Town of Hilton Head Island

Design Review Board Meeting

Tuesday, February 11, 2025, 2:30 PM

**Michael Anthony's Restaurant
37 New Orleans Road
Comment Response Letter
based on the May 14, 2024
Conceptual Submittal
January 28, 2025
DRB-000079-2025**

ARCHITECTURAL
SITE PLAN

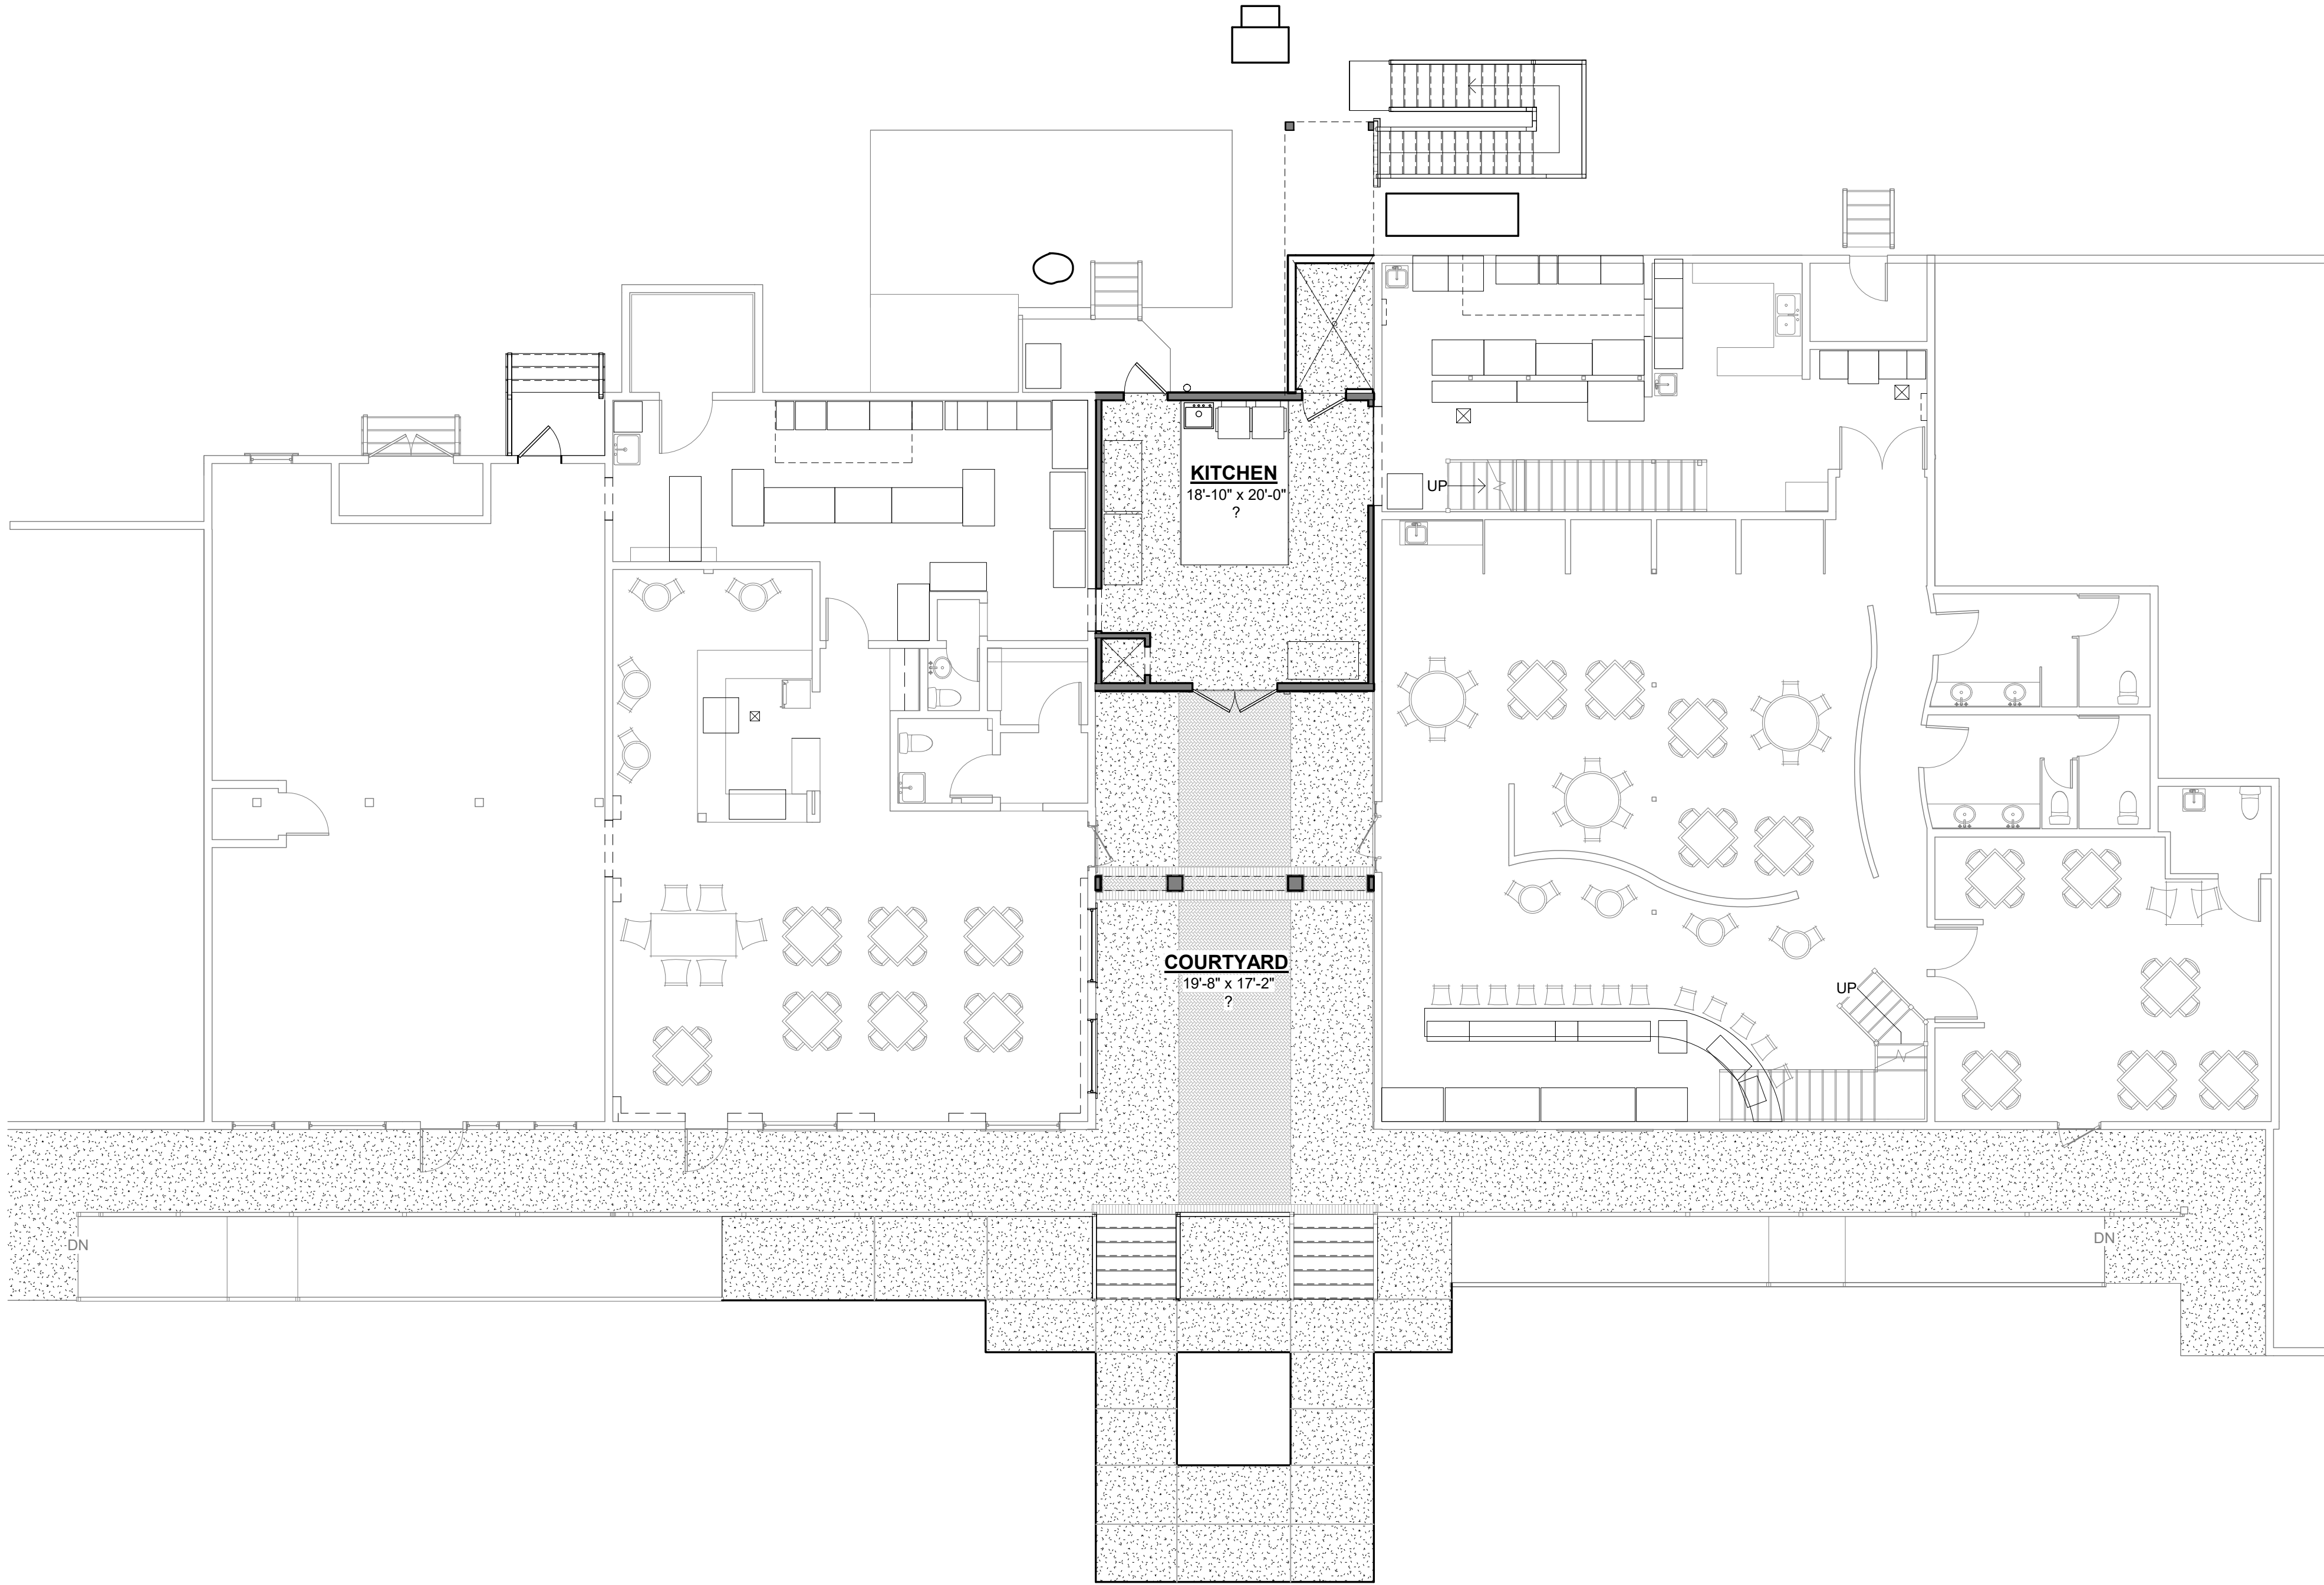
4. Consider a more deliberate plan for resolving the flooring design in the raised platform courtyard—remove pea gravel. **Will comply - See Arch drawings**

7. Will there be string lights in the courtyard? If so, provide details and cut sheets. **No**
8. Will the sidewalks remain as they currently are? If not, inform staff of any changes. **Existing pea gravel sidewalk will be demolished and new side walk to be added – See Arch drawings**

LANDSCAPE IRRIGATION

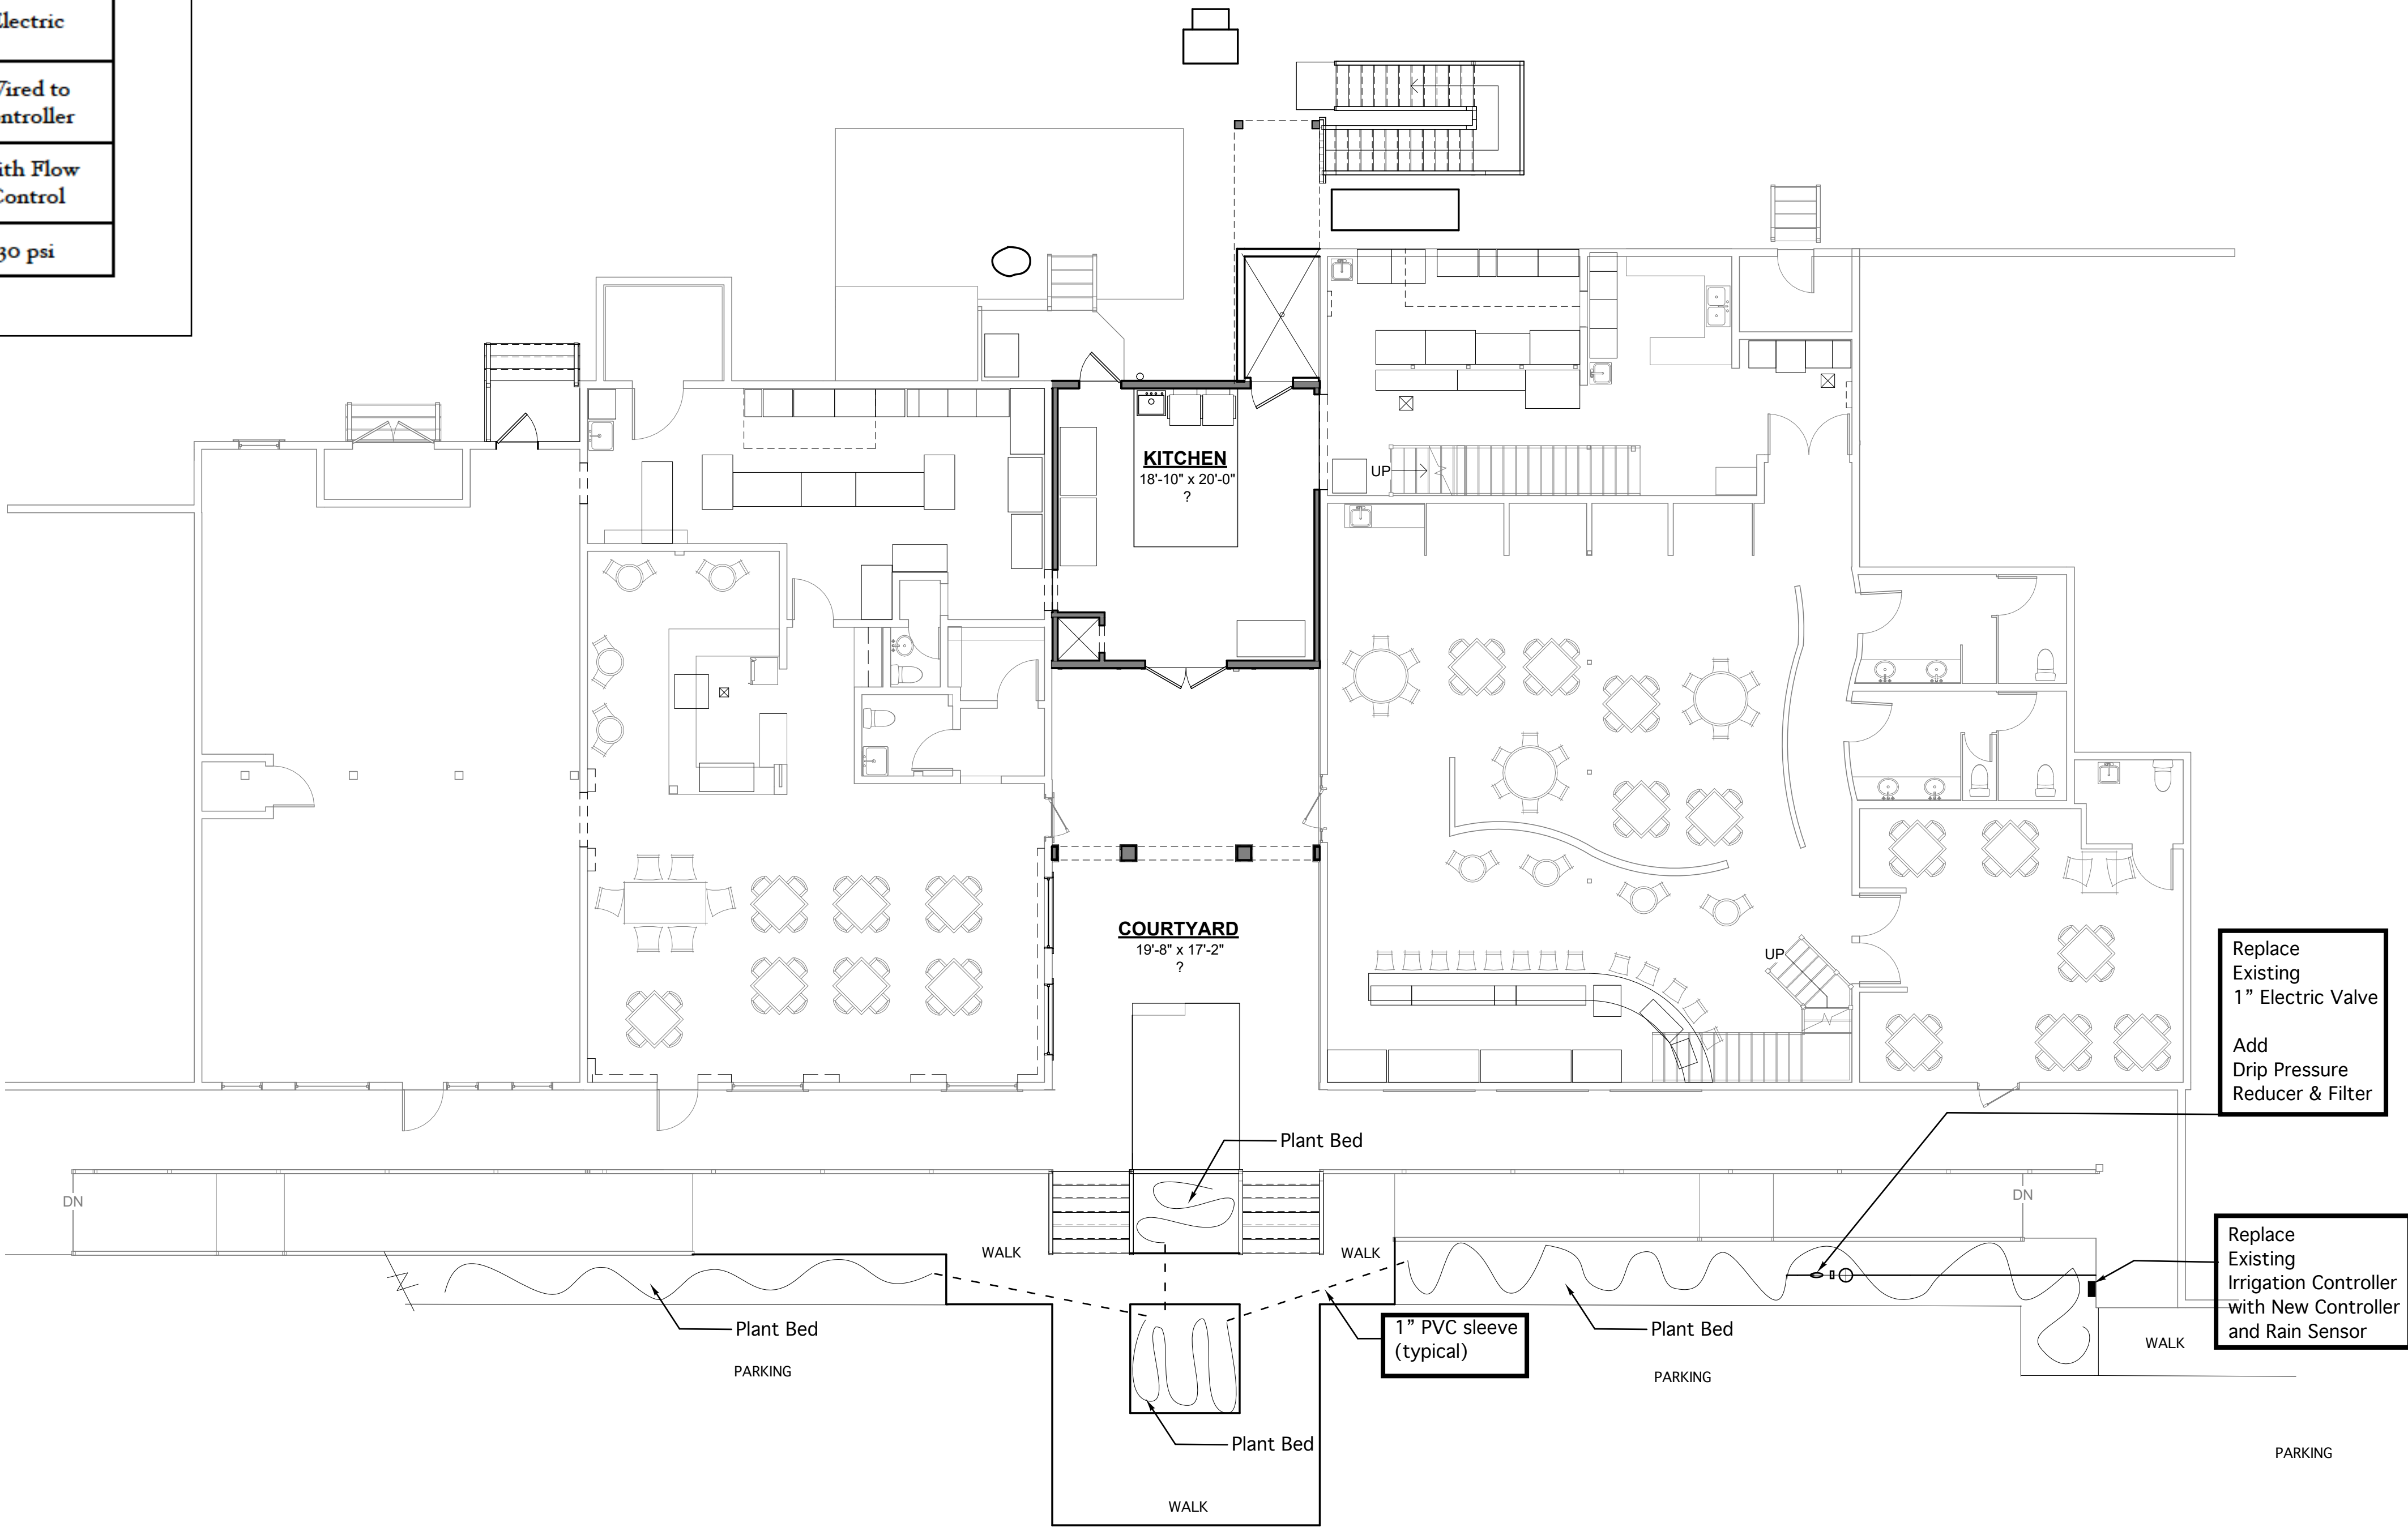
9. Ensure irrigation is included in the landscaping plan. **Will comply**
10. There is concern about the long-term health of the Italian cypress—landscaping should relate to the architectural design. **Italian cypress have been removed. See revised landscape plans attached**
